Project: VCSD 2024 Capital Project

Add. No.: Pre-Bid Addendum 002

A d d e n d u m

PARTIAL FLOOR FINISH PLAN @ AUDITORIUM 110

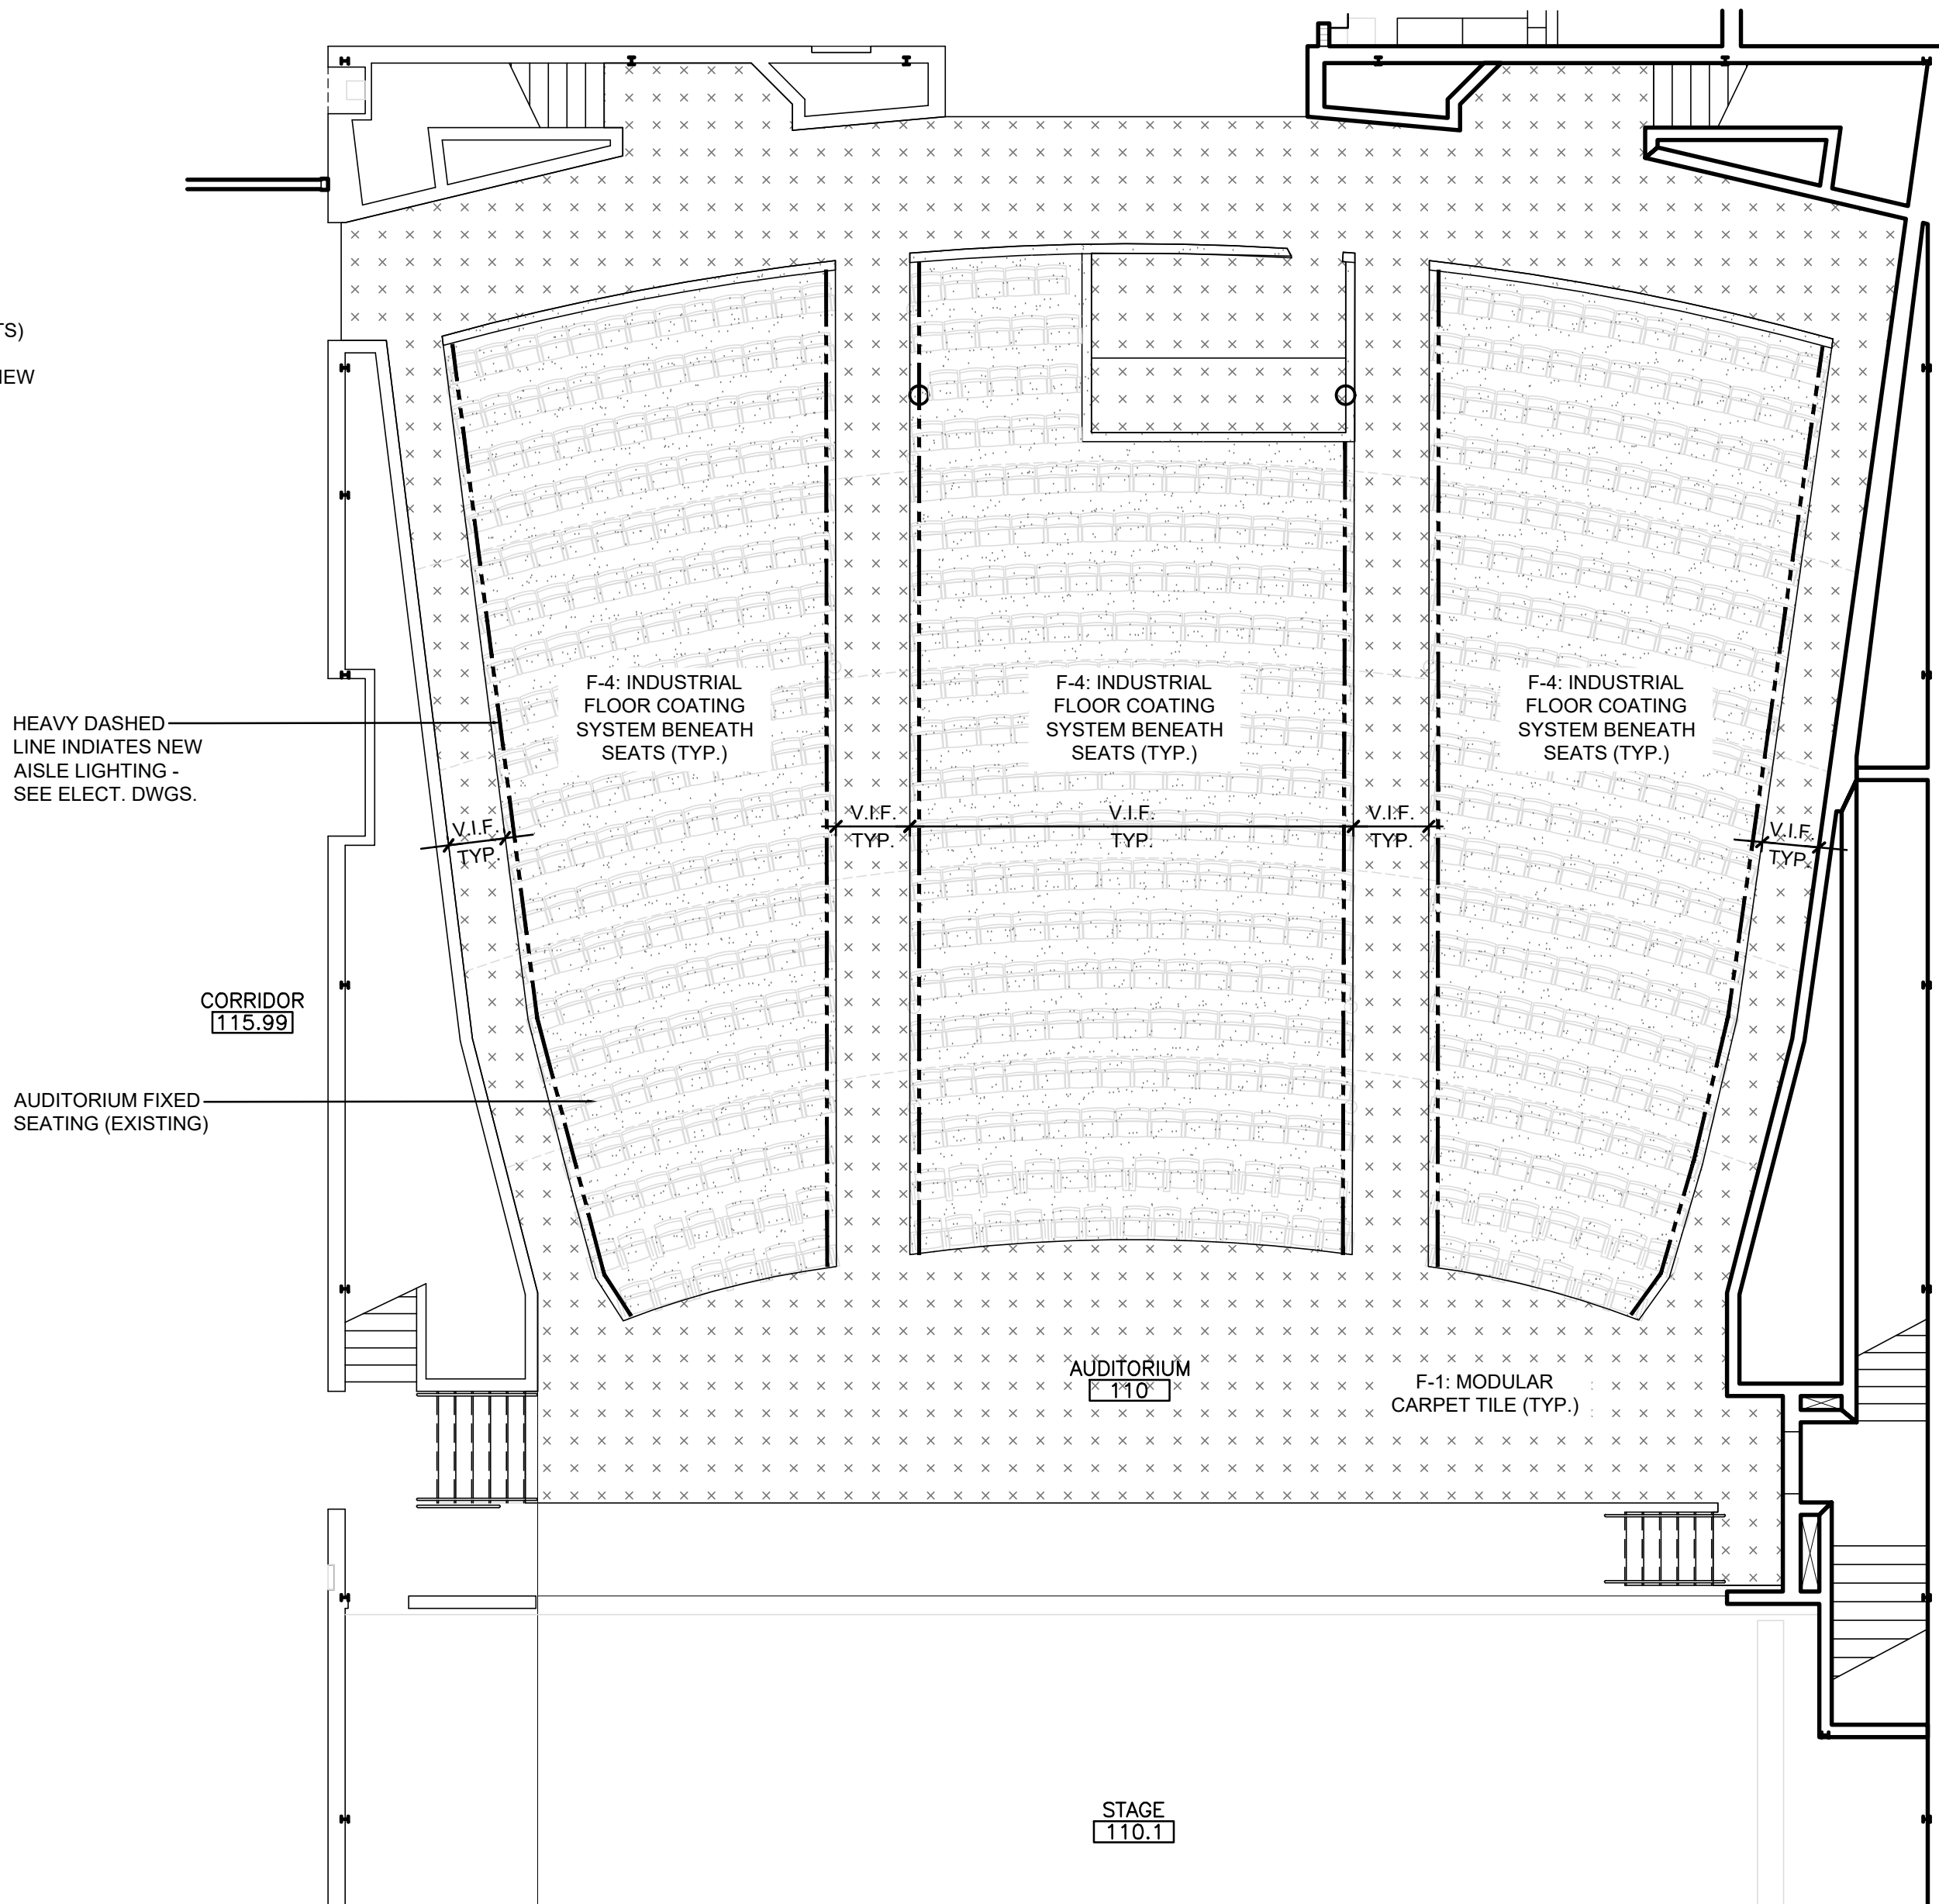
5. **HS-A-7.0** – Issued Revised Drawing

REVISED NOTE

- REFERENCE PARTIAL FLOOR FINISH PLAN AT AUDITORIUM 110 AT THIS SHEET FOR EXTENTS, LAYOUT & PATTERNING OF FLOOR FINISHES.
- INSTALL MODULAR CARPET TILE (F-1) IN A NON-DIRECTIONAL PATTERN AT ENTIRETY OF AUDITORIUM 110, INCLUDING AT SOUND BOOTH ROOM AT THE BACK OF THE SPACE. TYPICAL U.O.N. INSTALL INDUSTRIAL FLOOR COATING SYSTEM (F-4) UNDERNEATH EXISTING AUDITORIUM FIXED SEATING (ONLY). PROVIDE FOR A FLUSH / LEVEL TRANSITION BETWEEN FLOOR FINISHES. REFERENCE ELEC. DRAWING SHEET HS E-2.6 FOR LOCATIONS, EXTENTS, AND SPECIFICATION FOR AUDITORIUM AISLE LIGHTING.
